Access Compliance Report Public Rights-of-Way (Curb Ramps)

Main Street: HUNTLEY_DR Cross Street: WEATHERBY_RD Location: SE

ADA ID: RPRK211217123657 Ramp Type: Type 1 - Perpendicular Diagonal Initial Pass/Fail: Pass Overall Compliance: No Severity Score: 2

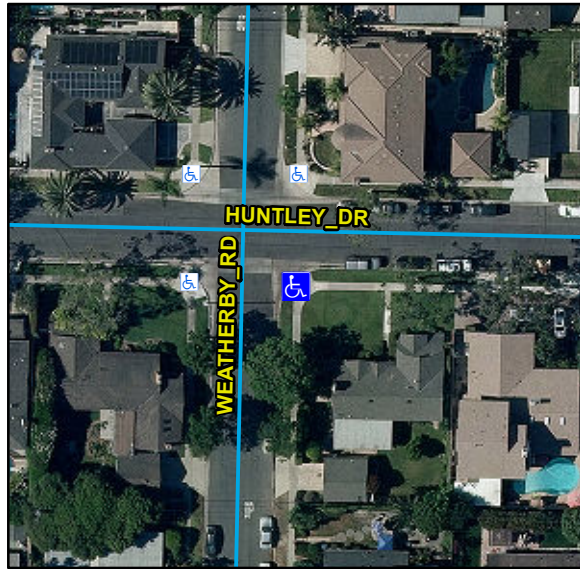
Remove & Replace Curb Ramp With Two New Directional Ramps or Equivalent.

R304.2.2, R304.2.2-Perp, R304.3.2-Para, R302.7, STD 1115
